UNITED STATES PATENT AND TRADEMARK OFFICE

10/622,491

Office Action Summary	Application No. 10/622,491	Applicant(s) ROBERTS, BRIAN	
	Examiner JUSTIN M. LARSON	Art Unit 3782

DETAILED ACTION

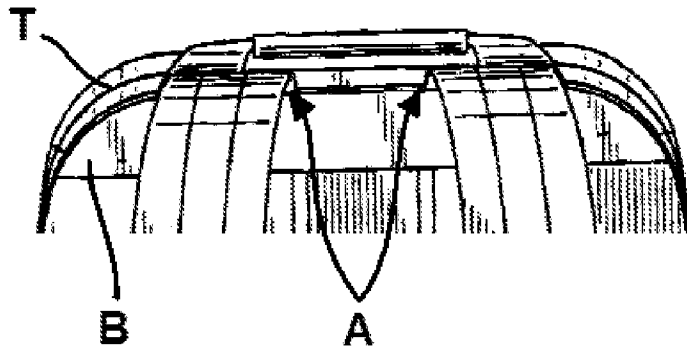
Regarding claims 38, 42, 44, 48, the back-facing face of the modified Ivarson et al. backpack has a top end (T, figure below) and the shoulder strap is connected to the back-facing face (B, figure below) at a position (A, below) spaced from the top end of the back-facing face.
